Town of Marlborough Planning Board Transmittal

MEMORANDUM

RE: Subdivision of Lands of Jeffrey Aldrich Our file #12-220004-00

The following information is submitted to the Town of Marlborough Planning Board for review and consideration in connection with the application of Jeffrey Aldrich for a Two Lot Subdivision and are in response to the comments received from MHE Engineering dated June 02, 2023.

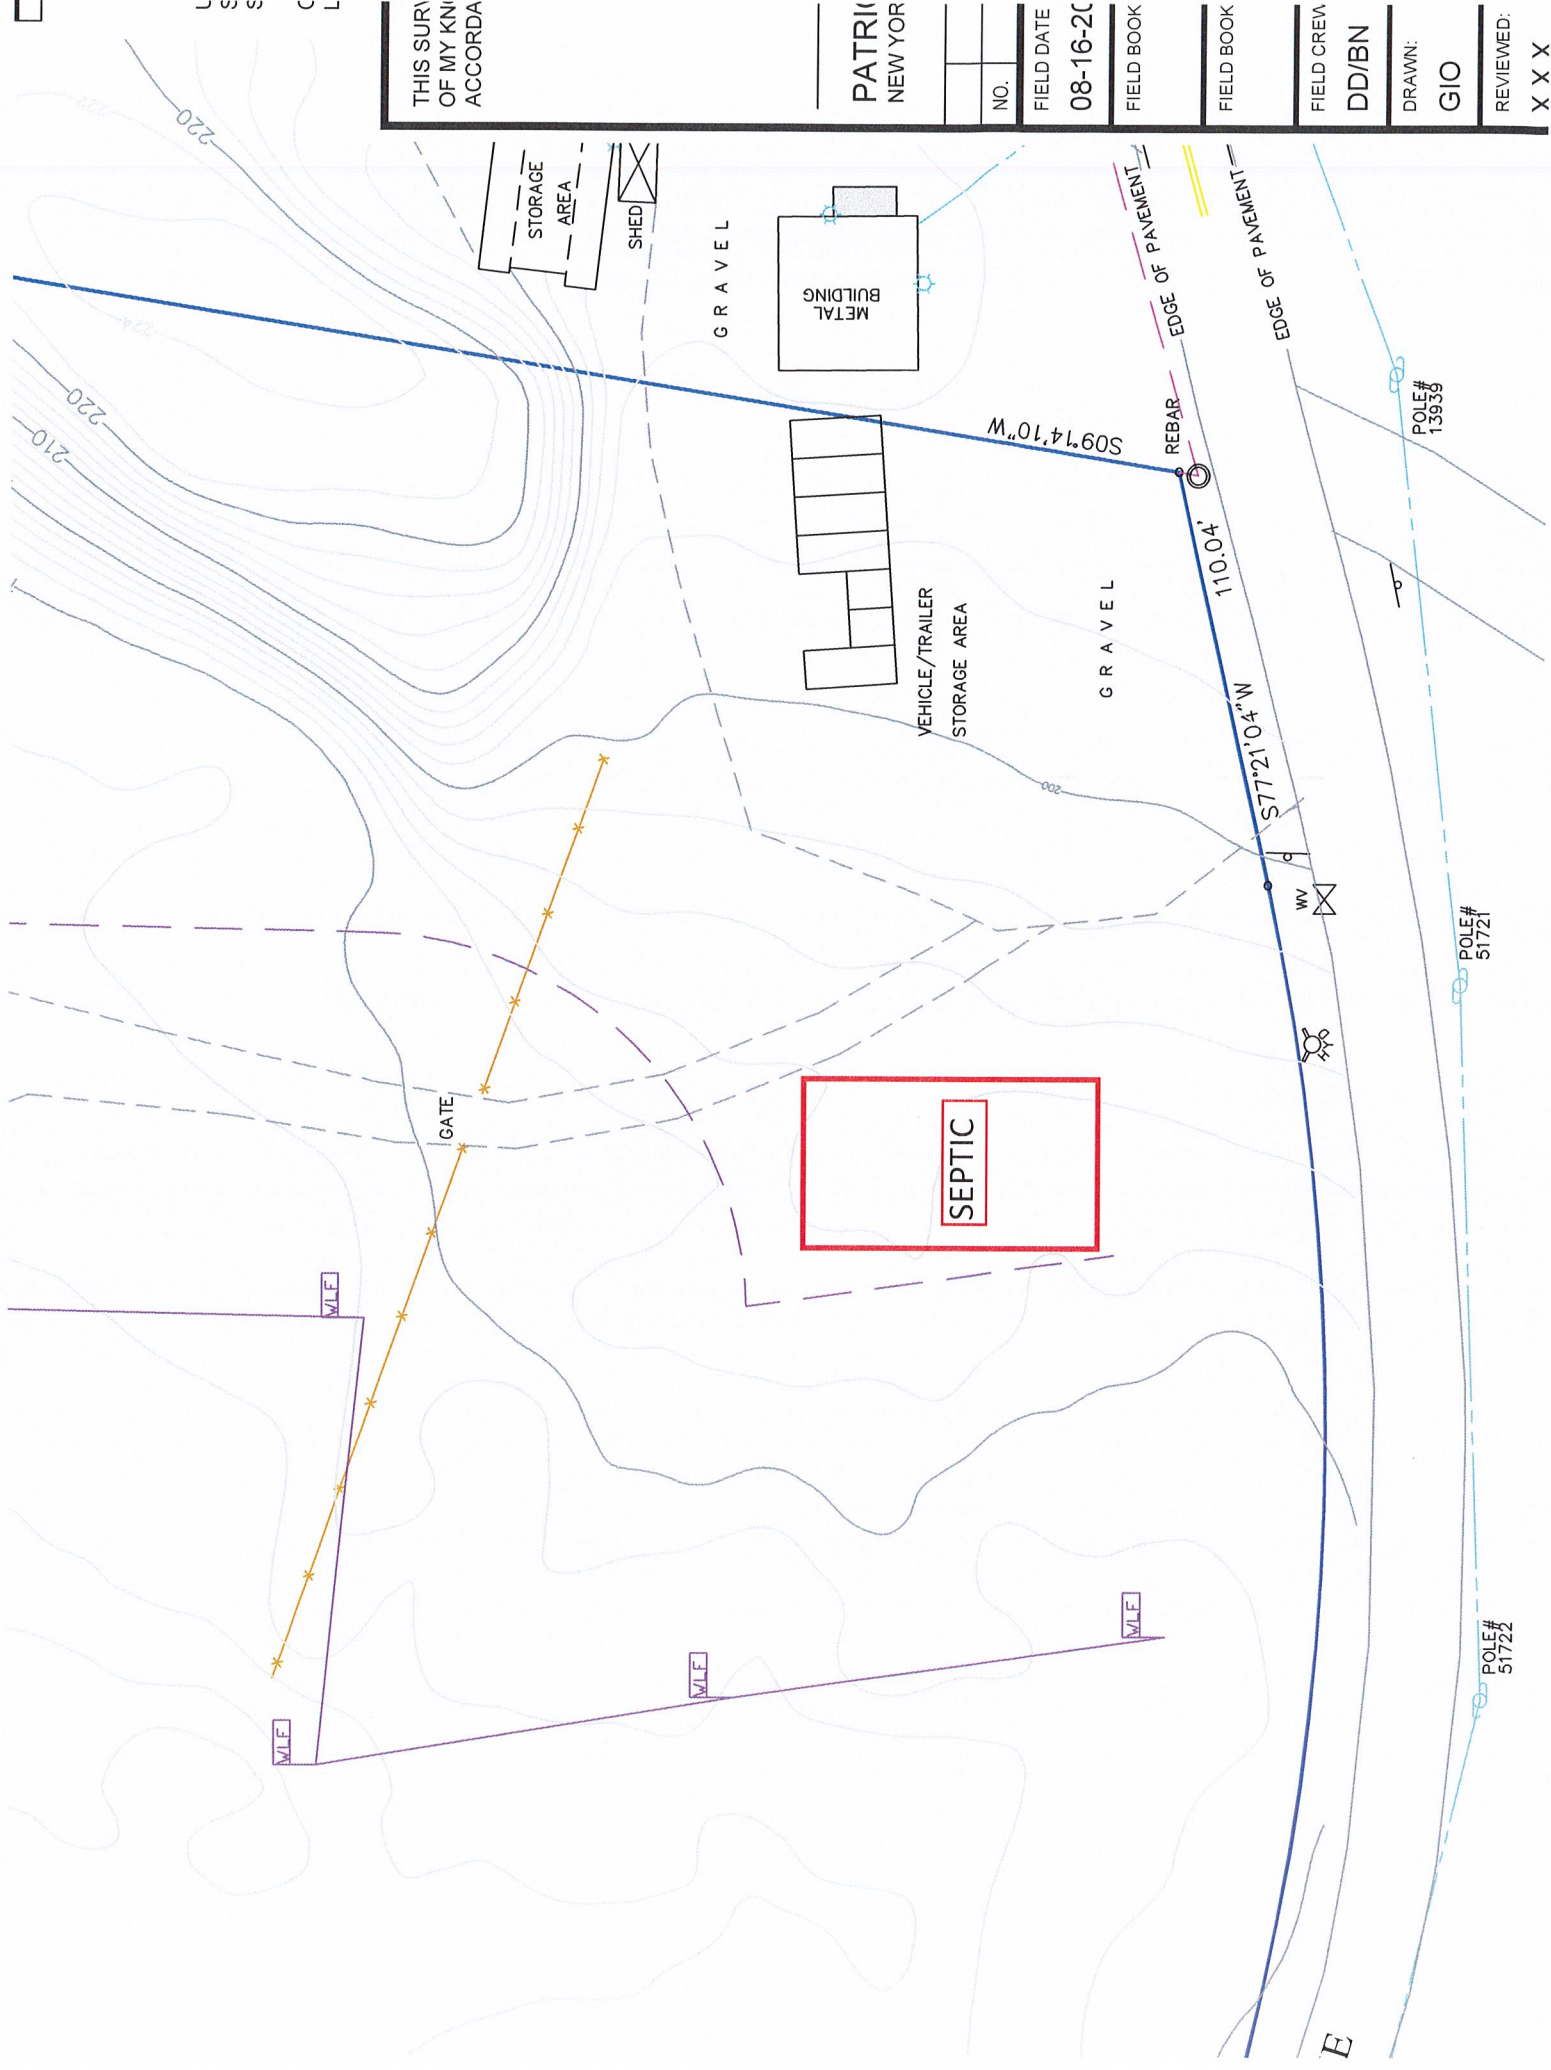
3. Percolation and deep testing should be performed on Lot #2 to identify a buildable area. While the lot is 12.42 acres, extensive wetlands exist on the site.

Percolation and deep test pits have been performed by Willingham Engineering and a suitable site was found for the design of fill systems for a primary and reserve septic system as per attached email and sketch.

We did deep tests in the presence of Chris Kresser of the UCDOH and also did perc tests, both of which passed for a small raised bed system in the location shown in the attached sketch. Any questions, don't hesitate.
